Docket Number:	01-AFC-07C
Project Title:	01-AFC-7C Russell City Energy Company
TN #:	200788
Document Title:	Roger Johnson Response Letter to Jewel Hargleroad RE: CalPilots Concerns
Description:	N/A
Filer:	Bruce Boyer
Organization:	CEC/Roger E. Johnson
Submitter Role:	Commission Staff
Submission Date:	10/8/2013 3:57:03 PM
Docketed Date:	10/8/2013

Re: Response to CalPilots Comments Regarding Russell City Energy Center

RUSSELL CITY ENERGY CENTER-TRAFFIC AND TRANSPORTATION FIGURE 1

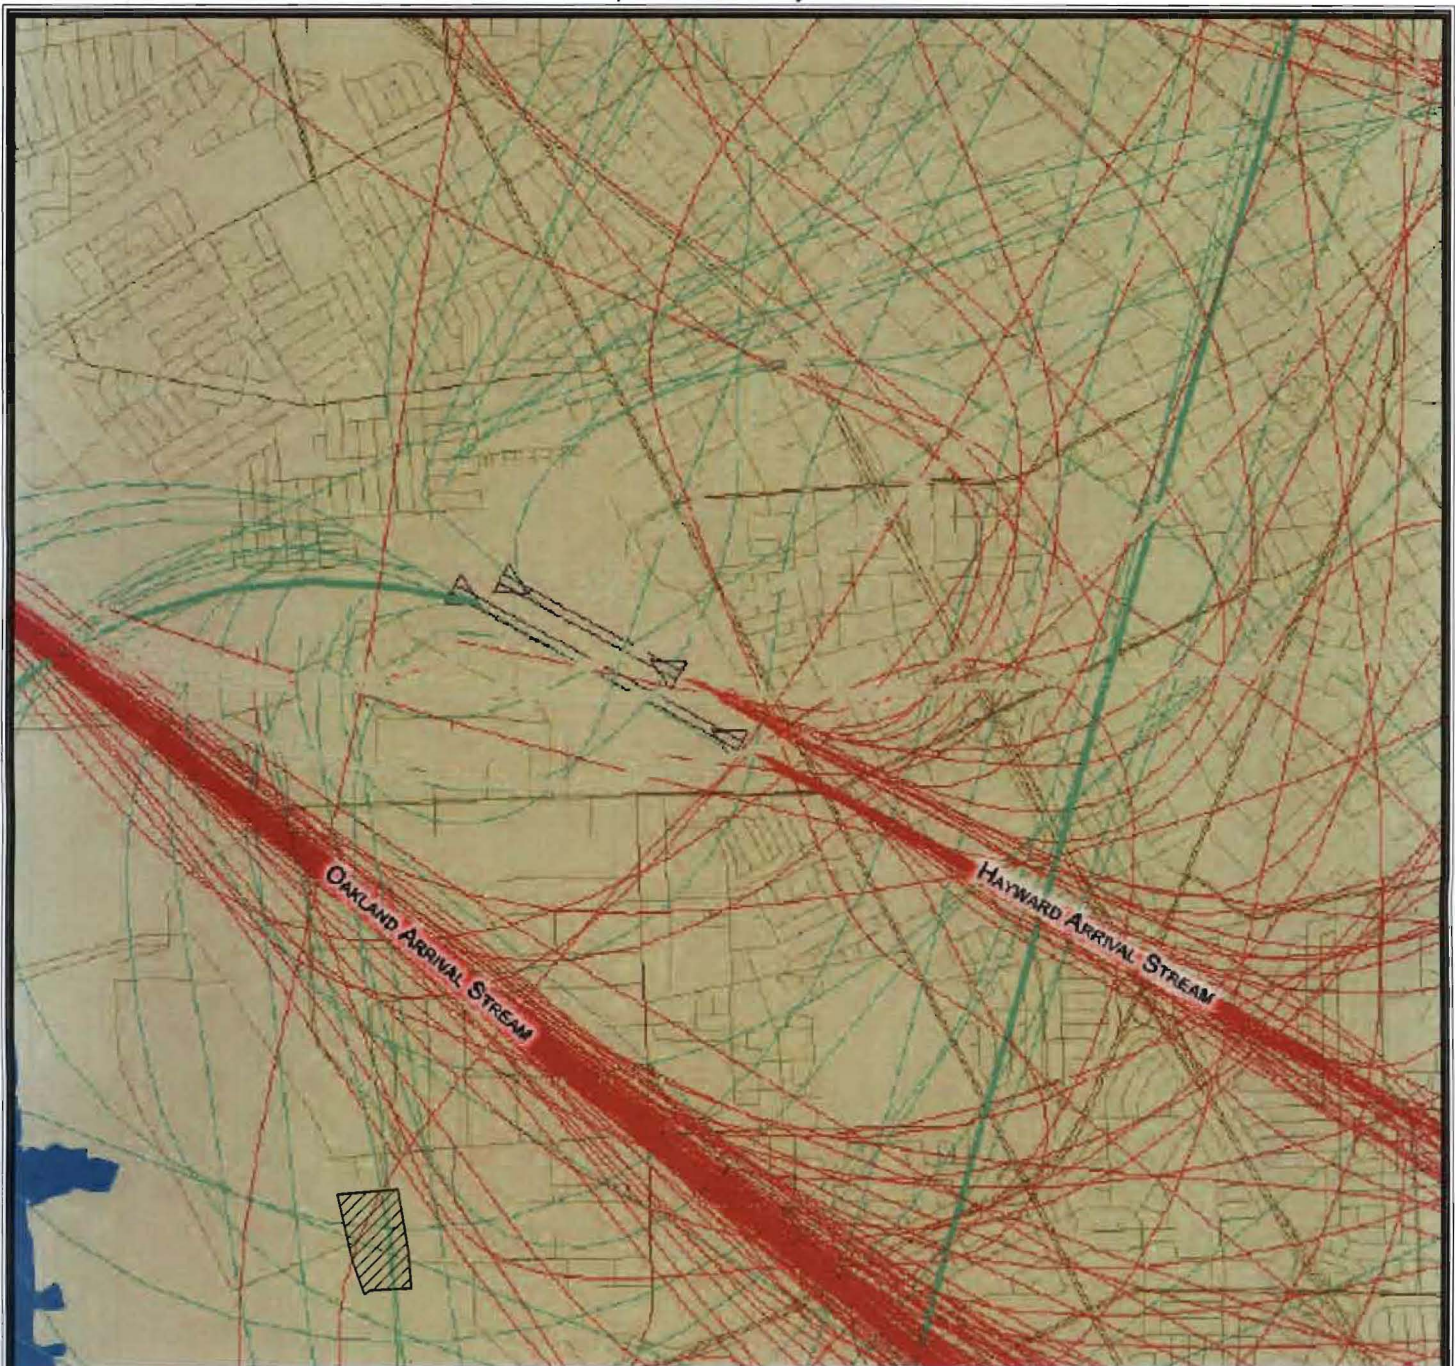
Staff has reviewed the statement by CPA in its August 21, 2013, letter claiming that thermal plumes from RCEC will cause the city of Hayward to be in violation of FAA Grant Assurances. The declaration states that RCEC thermal plumes are not compatible with normal airport operations for the Hayward Airport and would be incompatible with grant assurance contracts executed by the city of Hayward to "protect instrument and visual operations to the airport" and to "restrict the use of land adjacent to, or in the immediate vicinity of, the airport, to activities and purposes compatible with normal airport operations" (CPA 2007). As noted earlier, the October 2007 Energy Commission Decision on the RCEC concluded that the operation of the RCEC would not be a significant risk to aviation safety, but did include Condition of Certification **TRANS-10** to discourage pilots from flying over, or in proximity to, the RCEC below 1,000 feet.

The RCEC is about 1.5 miles southwest of the Hayward Airport in an area that experiences insignificant air traffic over flight. Staff used flight track data from the Hayward Airport Update Plan to generate attached **Figure 1**. The vast majority of the flight arrival stream to Hayward and Oakland airports is north of the RCEC. Only a small number of departure aircraft from Hayward flew over the area where the project would be located. The flight track data was gathered during a week's worth of operations in July 2008 (City of Hayward 2011). Though the number of aircraft operations would be different when compared to today's air traffic, the arrival and departure streams would be similar. Given the remarks and changes to navigational charts noted earlier and the recent start of commercial operations at the RCEC, it is likely that even fewer aircraft would fly over the project site than occurred in July 2008. Staff concludes, based on historical data and new measures implemented pursuant to Condition of Certification **TRANS-10**, that few aircraft would fly over the RCEC and therefore normal aircraft operations would occur.
